Statutory Review Design Response

Morland Gardens, London Borough of Brent

Following the receipt of comments from GLA, TFL & Brent Highways on the submitted scheme for Morland Gardens, this document has been produced in order to respond to those comments and show how the scheme has been amended.

1.
Greater London Authority - GLA/5444/01 - 09.03.2020
(GLA Comments)
2.
Transport For London - BRNT/20/7 - 20.03.2020
(TFL Comments)
3.
LBB Highways - D91/1324EP/1 - 25.03.2020
(LBB Highways Comments)

Upper Ground Floor

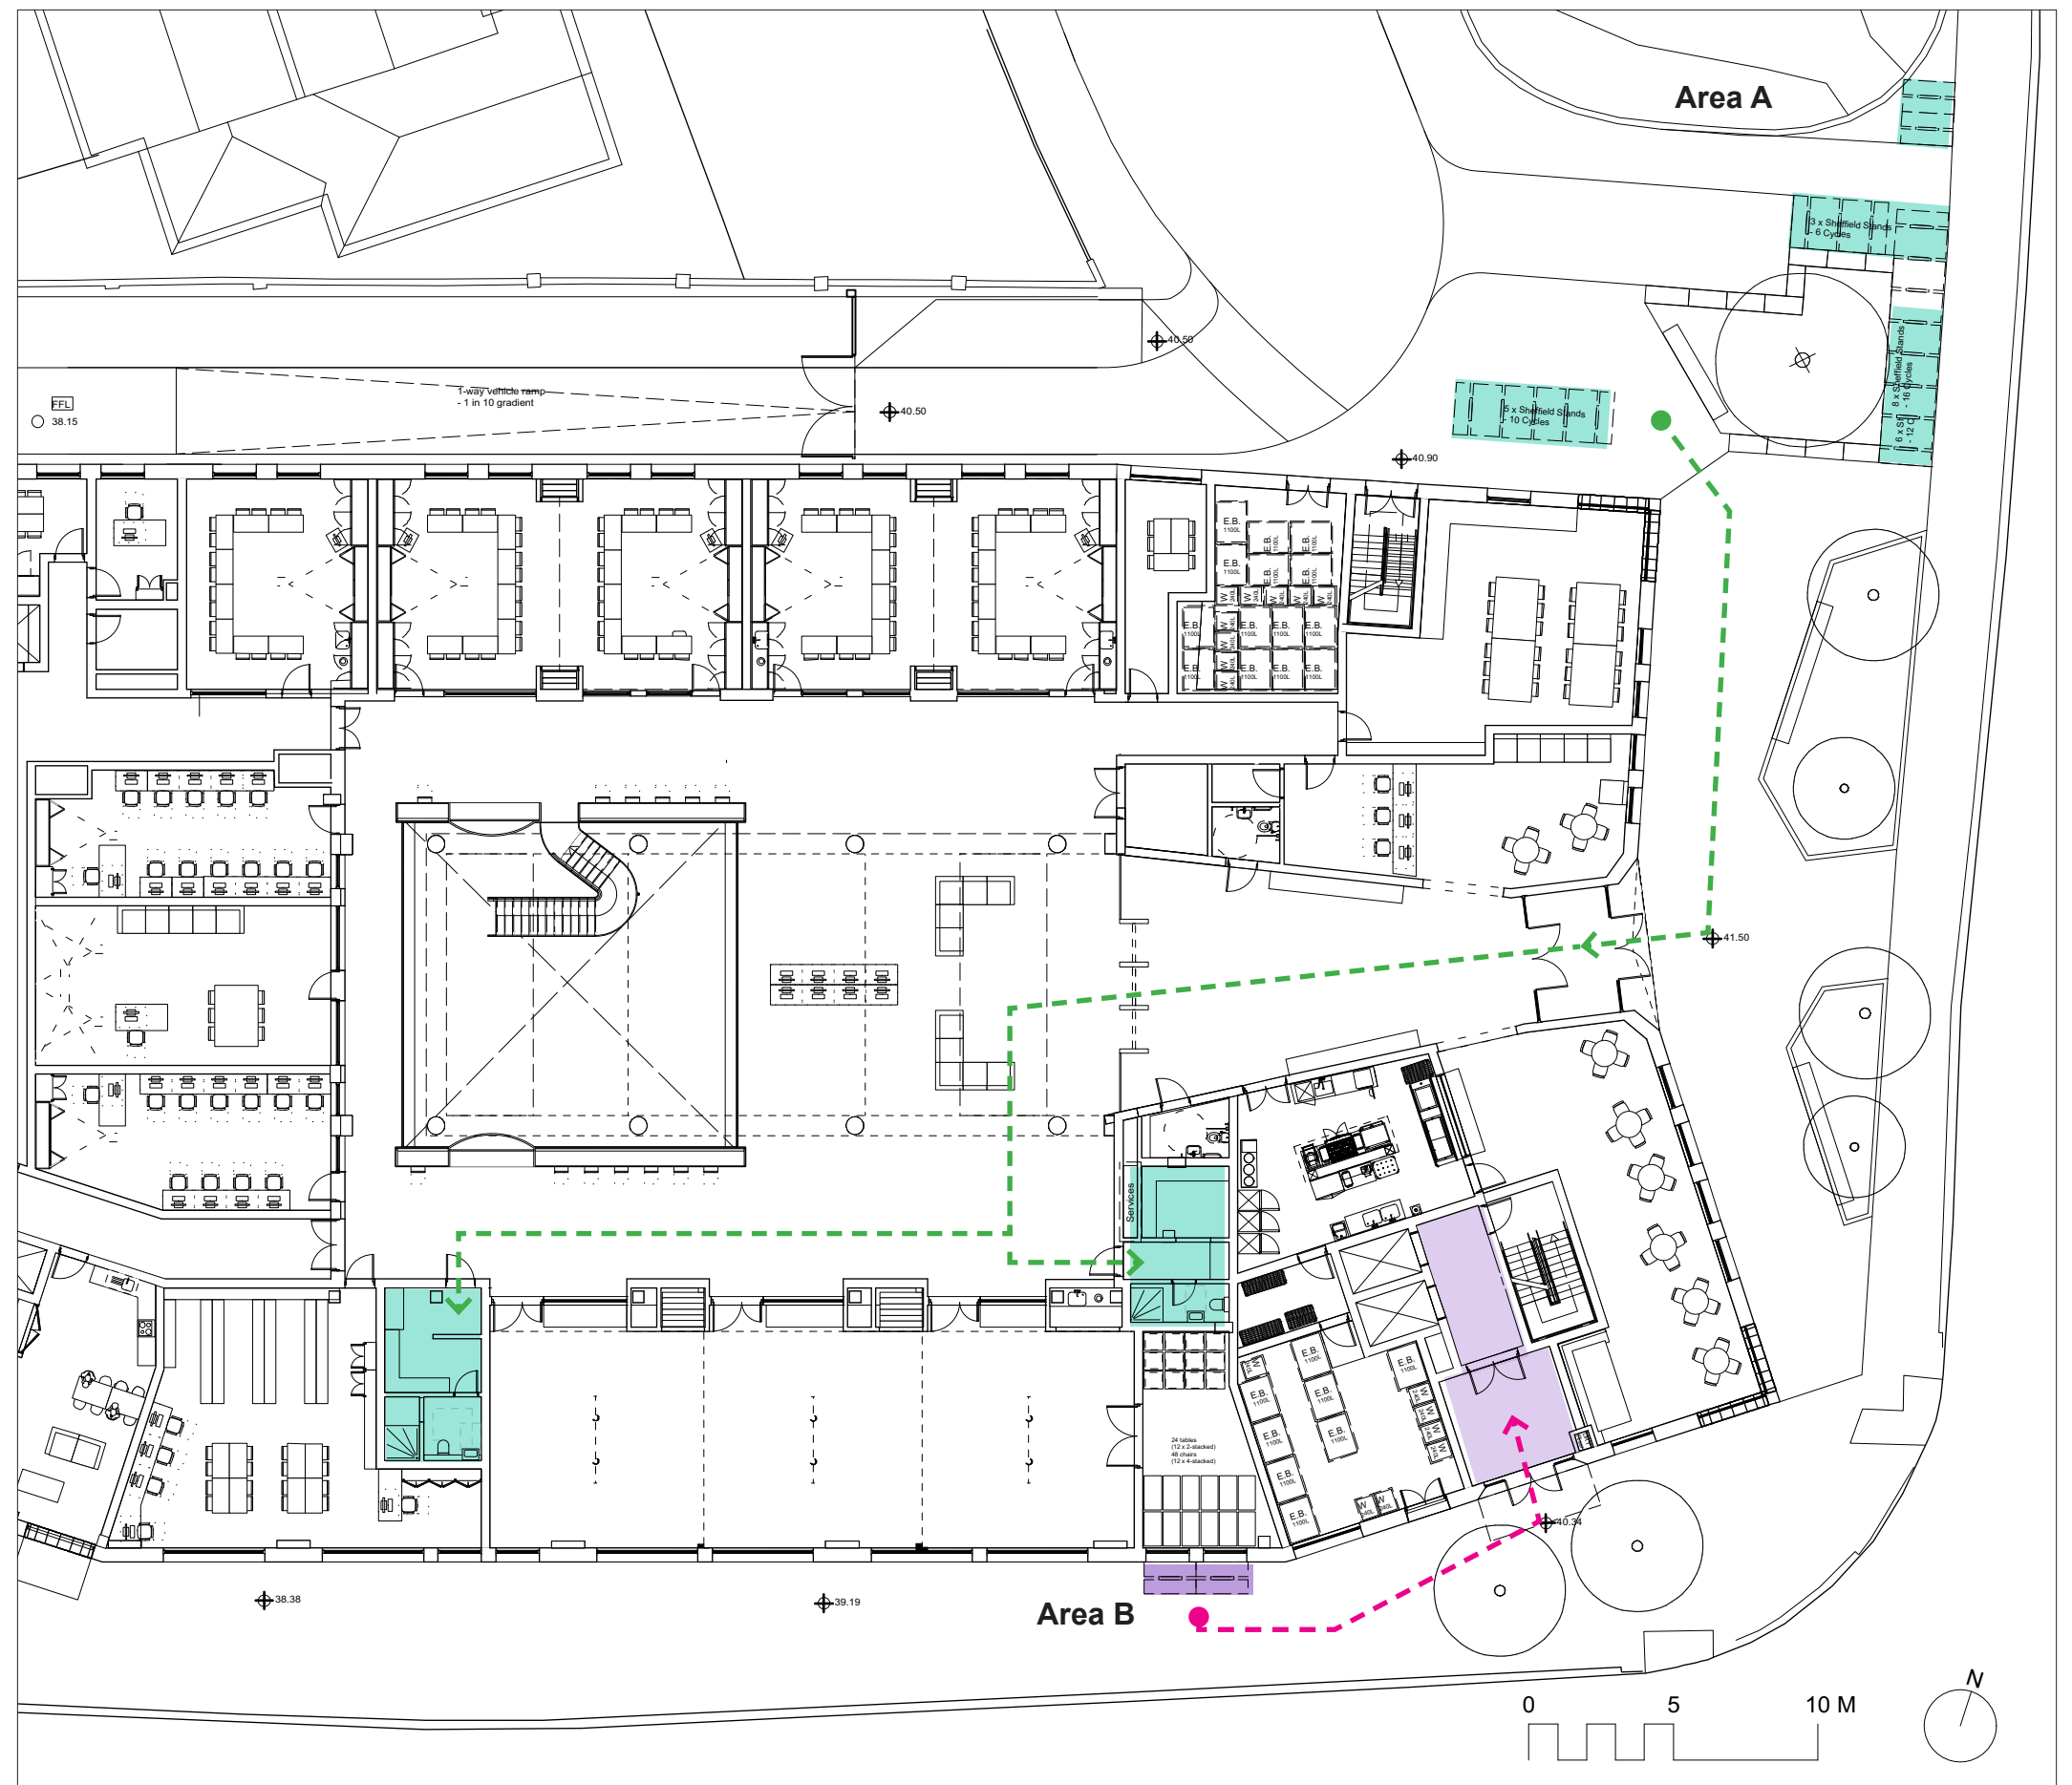
Further detail is also required on the cycle access routes to parking locations, the type of provision (including at least 20% Sheffield stands and further 5% wider spaces for non-standard bicycles)

‘two internal storerooms are proposed that provide sufficient secure long-stay storage capacity (138 spaces on two-tier racks) for the proposed flats, college and workspace uses. However, the aisle widths are restricted to the bare minimum of 2m and there is no provision for non-standard and adapted bikes (such as cargo bikes or tricycles), so the size and layouts of the stores need to be considered further.

Area A - Adult Education Short Stay - 36 spaces

This area has been amended from the Planning Scheme in order to accomodate the revised servicing solution

Adult Education Long Stay is now at Lower Ground to allow for the revised servicing arrangements (see over)

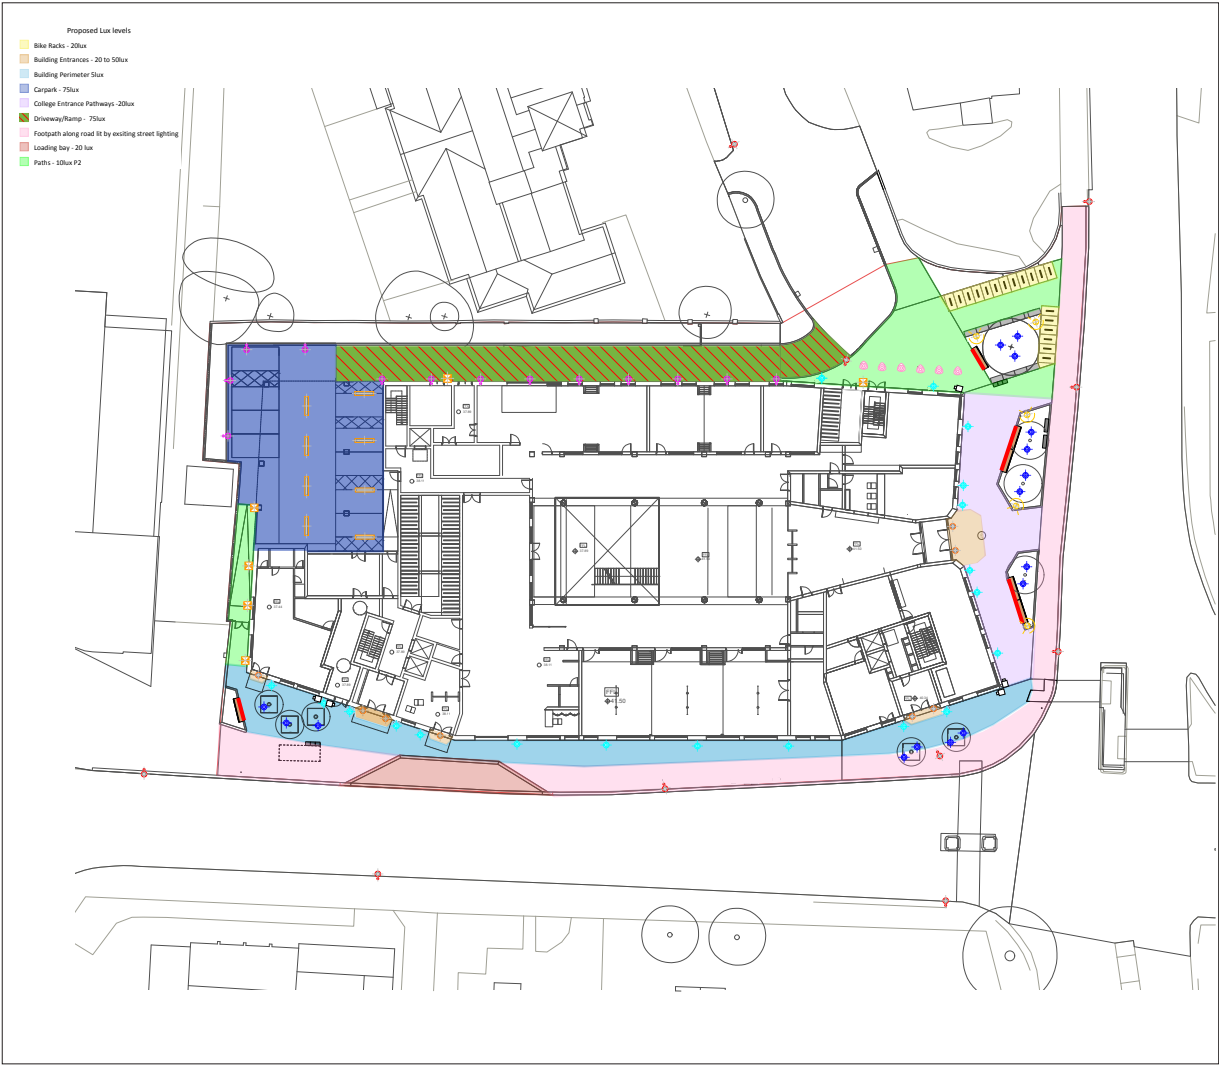
‘Within the site, 12 wall-mounted floodlights are proposed for the car park and access ramp, supplemented by eight ceiling mounted lights. These are designed to provide average illuminance of 30 lux along the access ramp and 75 lux in the car park. The lighting levels for the car park are fine, but the illuminance along the ramp should be increased to 75-100 lux.’

The External Lighting Strategy has been updated in order to comply with this request. A revised drawing is included as an appendix to this report showing an increase from the submitted 30 lux to 75 lux.
